December 7, 2015  
L-2015-293  
10 CFR 50.90

Re: Turkey Point Units 3 and 4  
Docket Nos. 50-250 and 50-251  
Response to Request for Additional Information Regarding  
License Amendment Request No. 237, Application to Revise  
Technical Specification Figure 3.1-2, Boric Acid Tank Minimum Volume

Response to Request for Additional Information Regarding Turkey Point  
Units 3 and 4 License Amendment Request No. 237:

Application to Revise Technical Specifications Figure 3.1-2, Boric Acid  
Tank Minimum Volume

Figure 1 – Typical Boric Acid Tank Elevation View

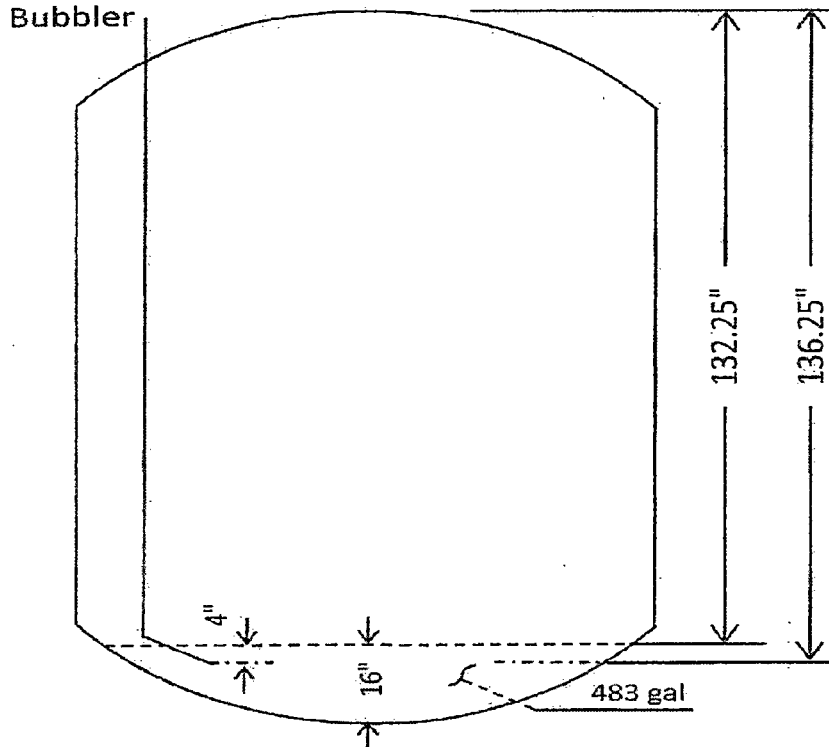
Please confirm that all three tanks are identical (e.g., in internal diameter and height of the tanks) and the method used for measuring the tank level.

The three Boric Acid Storage Tanks T-205A, T205B & T205C are identical in height and internal diameter.

Level Transmitter LT-106 measures the level in the 'A' Boric Acid Storage Tank (T205A), LT-108 measures the level in the 'B' Boric Acid Storage Tank (T205B), and LT-102 measures the level in the 'C' Boric Acid Storage Tank (T205C). These level transmitters are Rosemount model 1153DB4 differential pressure transmitters with an adjustable range of 0-25 to 0-150 inch water column (WC), and are calibrated to transmit a 4-20 mA<sub>dc</sub> signal representing the volume of their respective BAST from the top of the maximum vortex to the top of the tank.

The full height of the BASTs is 148.25 inches, and the vortex height is 16 inches. Subtracting the vortex height from the full height of the BASTs, results in a useable height of the tank of 132.25 inches. Additionally, the bubbler tube outlet for the level instrumentation is 4 inches below the vortex level. Therefore, the useable range is from 4 inches above the outlet of the bubbler tube to 136.25 inches above the outlet of the bubbler tube. As such, the subject transmitters are calibrated to a span of 4.0 to 136.25 WC. Figure 1 included below provides an elevation view of a typical boric acid storage tank.
